# UNITED STATES PATENT AND TRADEMARK OFFICE

APPLICATION NO.	FILING DATE	FIRST NAMED INVENTOR	ATTORNEY DOCKET NO.	CONFIRMATION NO.
10/535,137	01/25/2006	Leif Andersson	15090NP	3586

<b>Office Action Summary</b>	<b>Application No.</b> 10/535,137	<b>Applicant(s)</b> ANDERSSON ET AL.	
	<b>Examiner</b> Charles E. Cooley	<b>Art Unit</b> 1723

## **NON-FINAL OFFICE ACTION**

FIG. 3

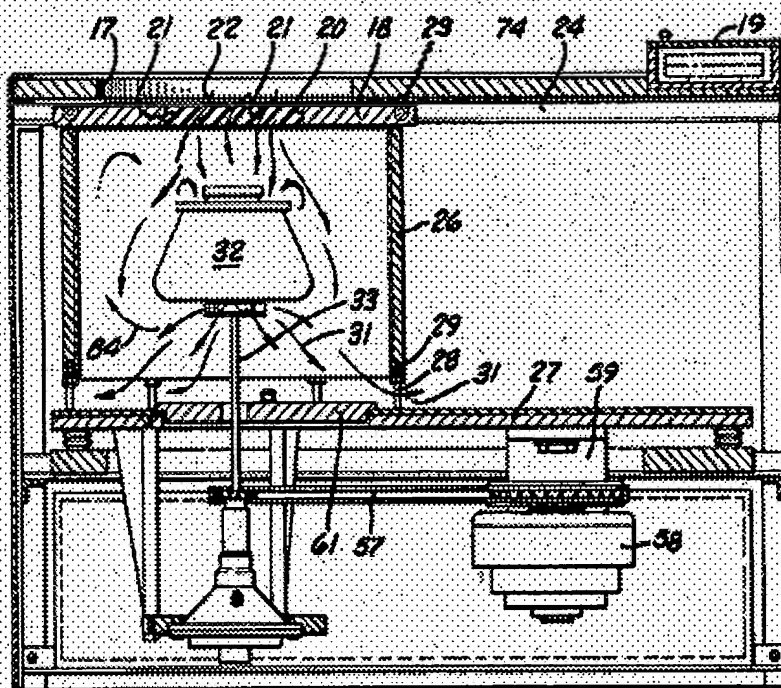
The patent to Pickels et al. discloses as seen below a device for centrifuging including rotor means 32 with thermal treating means for thermally treating centrifuging reaction vessels 89 containing samples in a thermocycling device; the rotor means 32 comprises at least one fan blade 71 and/or 83 which force ambient gas to through the rotor means and pass the samples; at least one gas conducting passage 69 is arranged in the rotor means 32; wherein the rotor means 32 comprises a base portion (above 82) and a lid portion 86, 87, in between which an inner space 69 is formed wherein the fan blades 71 and/or 83 are arranged; the lower region of the rotor means 32 is provided with at least one through hole (above 82); the upper region of the rotor means 32 is provided with at least one through hole 87; the fan blades 71 are arranged at the inside of the base portion of the rotor means 32; wherein the fan blades 71 are arranged at the inside of the lid portion 86, 87 of the rotor means 32; a plate 86; the gas is ambient air (col. 3, lines 41-49).
